127TH UNECE GRSG: THE UK'S PROPOSED AMENDMENT TO UNECE REGULATION 167

DR STEVE SUMMERSKILL

- 
-
- The UK is proposing an amendment to UNECE 167
 - The following presentation summarises the evidence gathered for this amendment and the work that has been done to provide a solution
 - First, we will describe how UNECE 167 was defined to provide context

IMPROVING VOLUME SCORE WITHOUT IMPROVING DIRECT VISION OF AREA OF GREATEST RISK

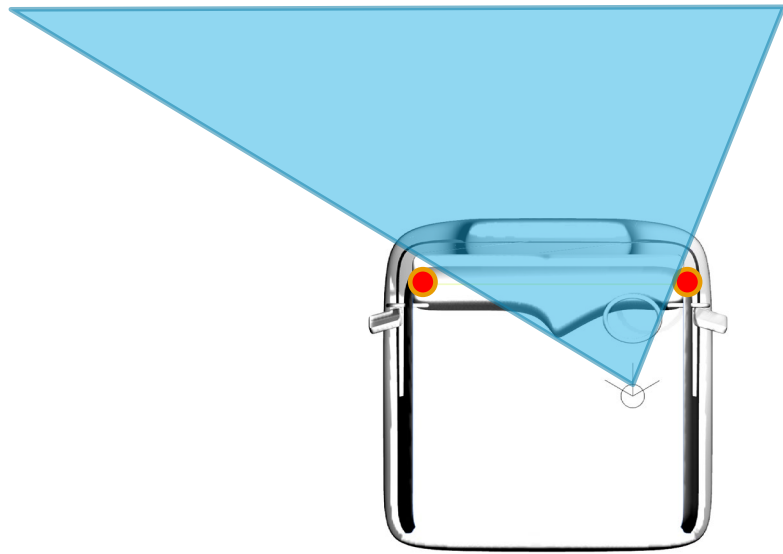
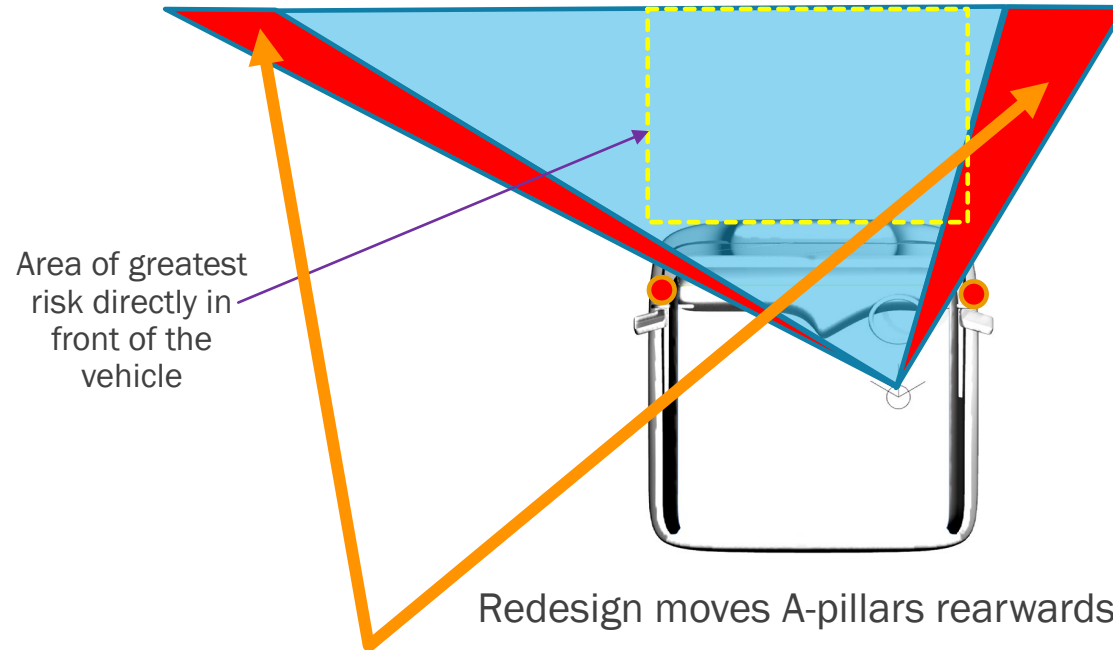
- If manufacturers choose to move the A-pillars rearwards towards the driver compared to the original sample they will be able to gain volume without improving the view of the area of greatest risk
- i.e. the design could do nothing to improve the visibility of VRUs directly in front of the vehicle in the area of greatest risk and still meet frontal minimum requirements

Red areas show volume gained outside of area of greatest risk for frontal collisions, **potentially allowing a vehicle to pass the minimum requirements without improving direct vision directly in front of the vehicle in the area of greatest risk.**

Redesigned dashboard on the passenger side

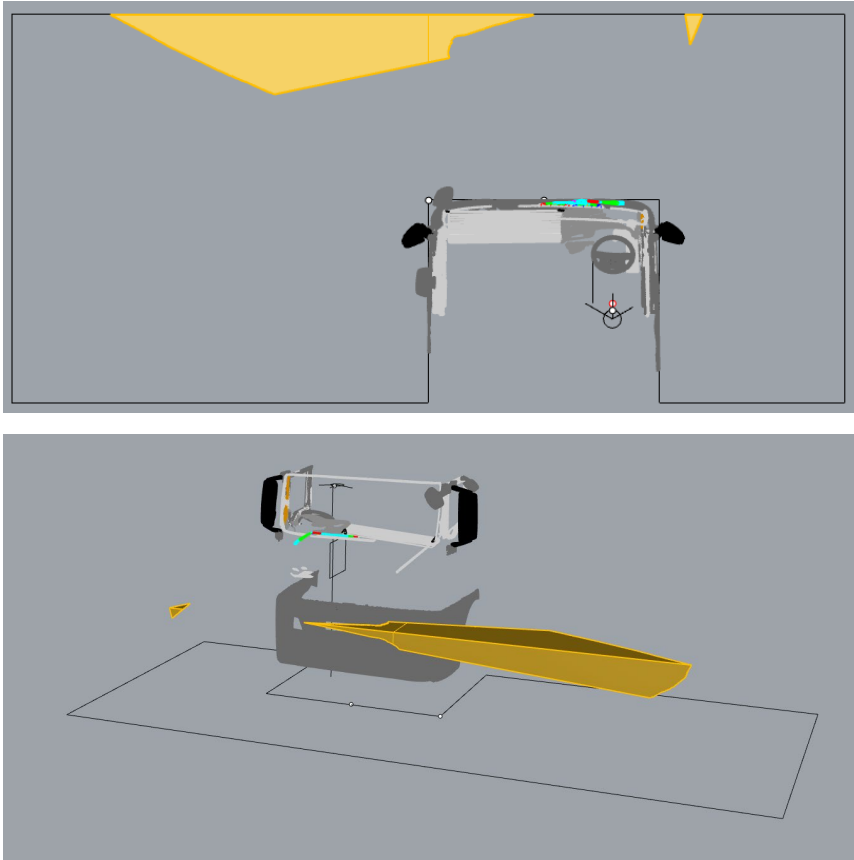
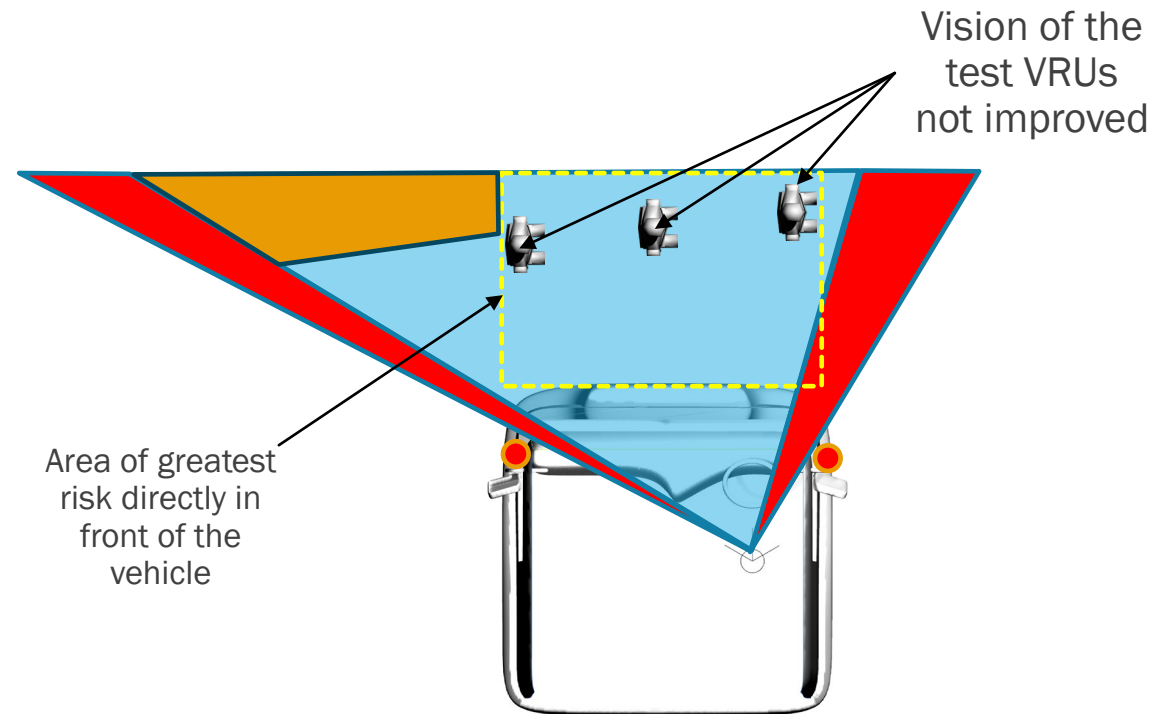
- In addition, further volume can be gained by lowering the passenger side dash board area, but the volume gained is also outside of the area of greatest risk. This approach has been suggested by ACEA

This is the worst performing HGV in the sample used. It can achieve the frontal volume requirements by lowering the passenger side dashboard without improving the direct vision of the three test Vulnerable Road Users at all

It has an average front VRU distance of over 2.8m, so a large direct vision blind spot in front of the vehicle

Orange areas show volume gained outside of area of greatest risk for frontal collisions, **potentially allowing a vehicle to pass the minimum requirements without improving direct vision directly in front of the vehicle in the area of greatest risk.**

Three VRUs in front of the cab as defined in Series 00

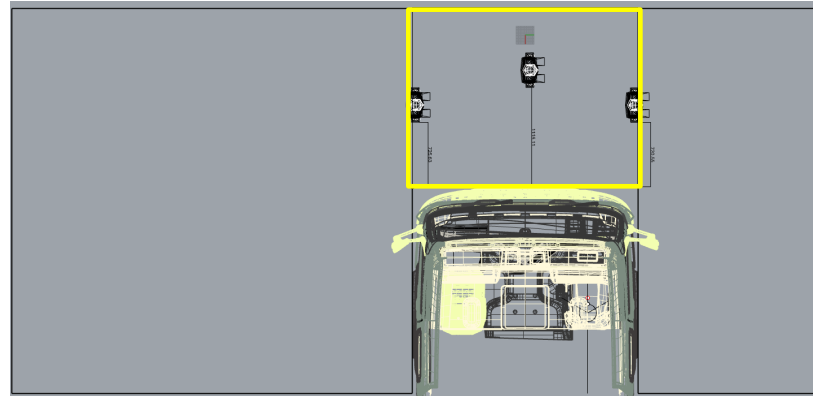
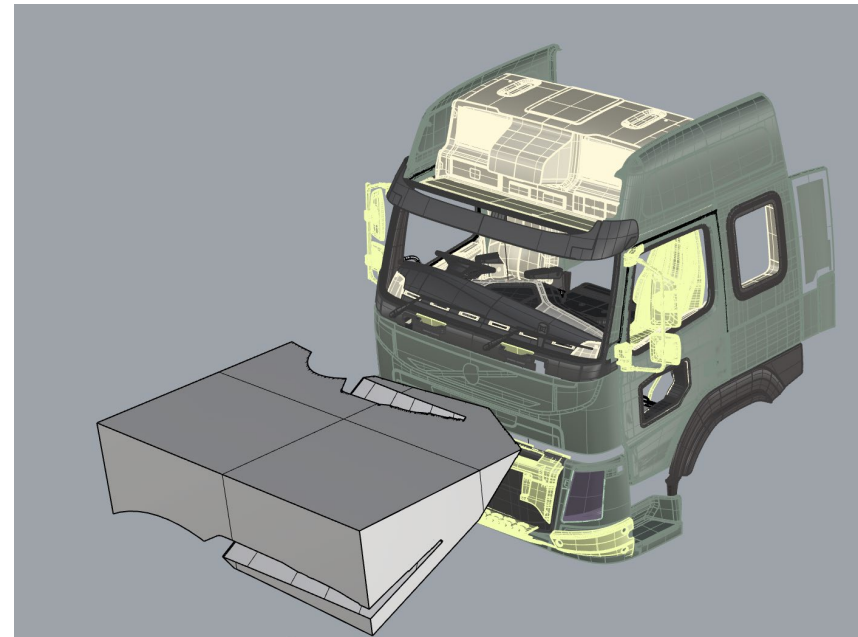
- The volume approach is still preferred by all parties as it is an accurate method that can be performed in CAD during design development
- So the question is what volume is equivalent to the need to see three VRUs directly in front of the vehicle?
- We needed a way to define a frontal volume
- We have taken **the lateral extents** of the vehicle to define the volume directly in front of the vehicle as this is the area that contains the three VRUs for the Series 00 method. **Subsection Frontal Visible Volume (SFVV)**
- Therefore, plotting the VRU distance against the SFVV Volume gives a trend line that can be used to calculate the volume that should be seen at a certain VRU distance, in the same way as the method used to define the volume requirement for the series 00 version

Plan view of the area within which the VRUs are contained, therefore VRU distance should correlate well with volume as per the previous uses of this method

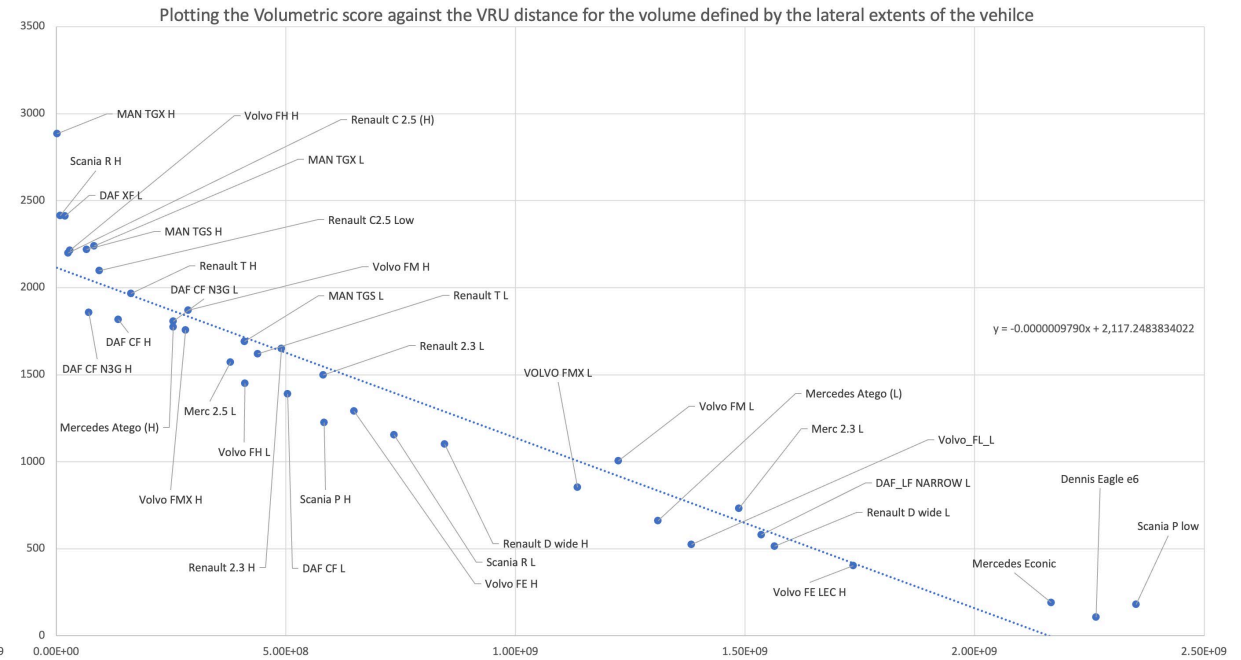
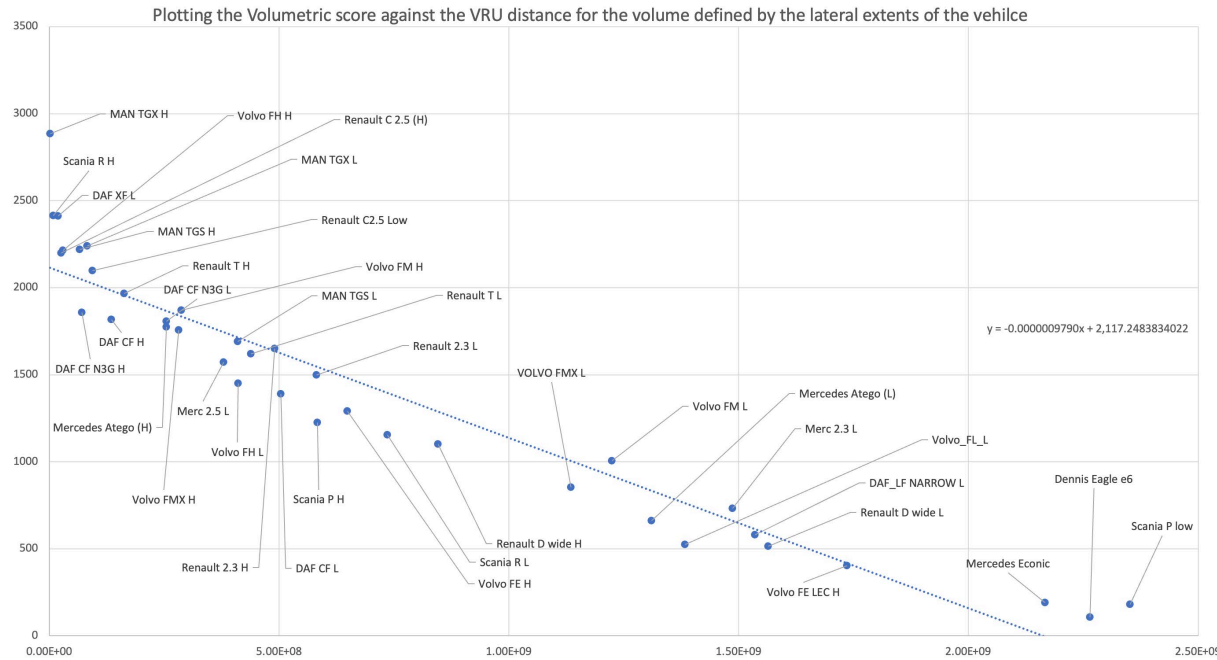
- We have performed this process for 36 vehicles with the following results
- Level 1 vehicles (urban) would need to be able to see **0.48m³** in the SFVV area (average VRU distance 1653mm)
- Level 2 (construction) and 3 (long haul) vehicles would need to be able to see **0.169m³** in the SFVV area (average VRU distance 1958mm)

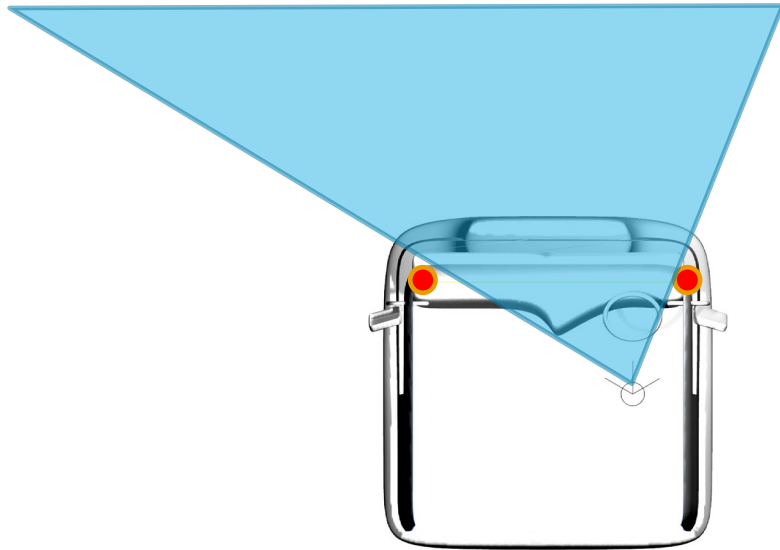
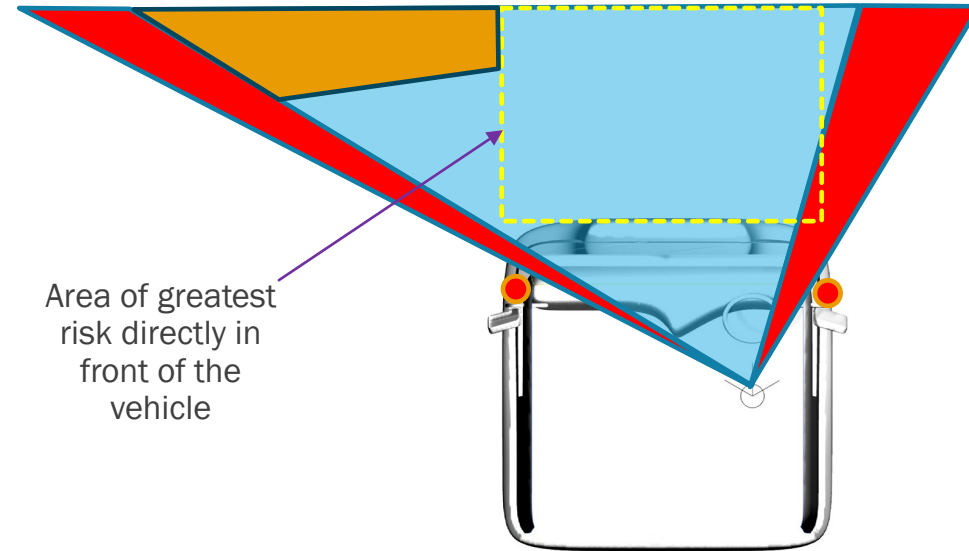
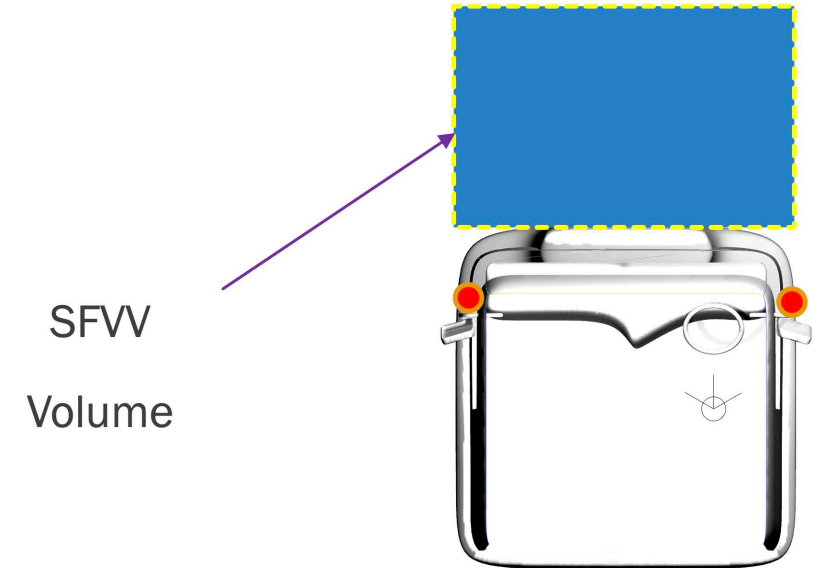
- By requiring a design to allow visibility of the **Subsection Frontal Visible Volume (SFVV)** we can avoid the issue shown below.

Red areas show volume gained outside of area of greatest risk for frontal collisions, potentially allowing a vehicle to pass the minimum requirements without improving direct vision directly in front of the vehicle.
